# Access Compliance Report

## Public Rights-of-Way

### (Curb Ramps)

Intersection ID: 44929	Main Street: TWIN_BROOK_DR	Cross Street: NATHAN_DR	Location:	E
ADA ID: DC8DDE7E7DE6	Ramp Type: Perp	Initial Pass/Fail: Pass	Overall Compliance: No	Severity Score: 0
Codes/Mitigation Info/Possible Solution		Field Measurements/Component Compliance

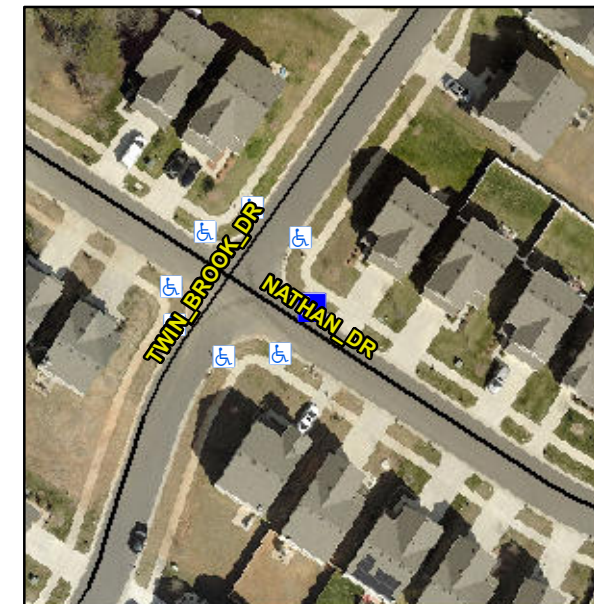
**Not Found, R305.2**

Compliance	Description	Data	Compliance	Description	Data
N/A	Ramp Length (in)	94.5	Yes	Ramp Slope (%)	5.9
Yes	Ramp Width (in)	59.5	Yes	Ramp XSlope (%)	0.4
N/A	Flare Type LT	Sloped	N/A	Flare Type RT	N/A
N/A	Flare Slope LT (%)	4.2	N/A	Flare Slope RT (%)	7.5
N/A	Flare Traversable LT?	No	N/A	Flare Traversable RT?	No
Yes	Landing Length (in)	59.5	Yes	DWS Provided?	Yes
Yes	Landing Width (in)	59.5	Yes	DWS Contrast?	Yes
Yes	Landing Slope (%)	0.9	Yes	DWS Length (in)	24.0
Yes	Landing X Slope (%)	0.1	Yes	DWS Full Width?	Yes
N/A	Landing Curb? (Y/N)	No	No	DWS Offset (in)	4.5
N/A	Shared Landing?	No			
Yes	Gutter Ponding?	No	Yes	Gutter Slope (%)	1.4
Yes	Gutter Lip Ht (in)	0.0	Yes	Gutter X Slope (%)	1.0
N/A	Painted X Walk1?	No	N/A	Painted X Walk2?	N/A
	X Walk 1 Direction	To SW		X Walk 2 Direction	N/A
N/A	X Walk 1 Width (in)	N/A	N/A	X Walk 2 Width (in)	N/A
	X Walk 1 Slope (%)	3.4		X Walk 2 Slope (%)	N/A
	X Walk 1 X Slope (%)	1.2		X Walk 2 X Slope (%)	N/A

**Remove & Replace Entire Ramp.**
